UNITED STATES PATENT AND TRADEMARK OFFICE

Office Action Summary

10/662,702

DETAILED ACTION

FIGURE 1

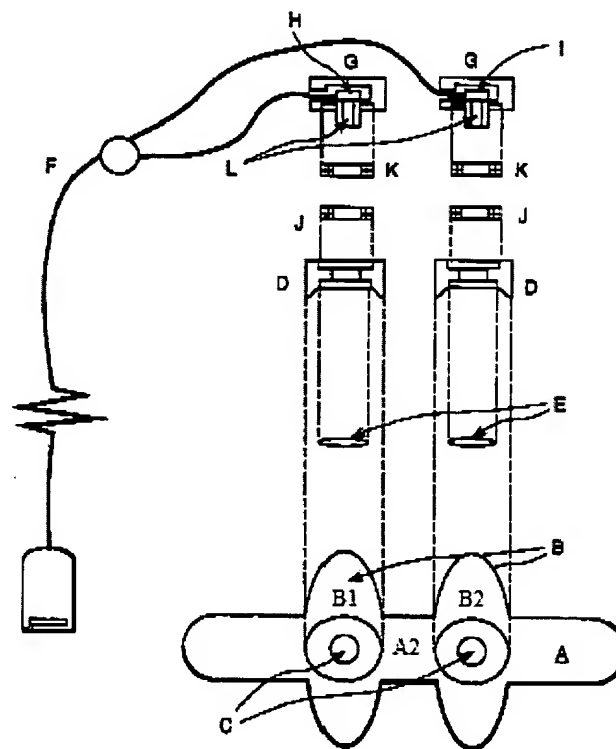
on the light emitting diode housing (col. 3, lines 27-35). Figure 1 of Parker'868, shown below, discloses the system wherein the securing means comprises two separate, adjustable straps, B1 and B2, wherein the first strap B1 is in physical communication with the detector housing when the detector housing is placed in aperture C, and the second strap B2 is in physical communication with the light emitting housing when the light emitting housing is placed in aperture C, and straps B1 and B2 are integrally formed by strap A2, to form apparatus A.
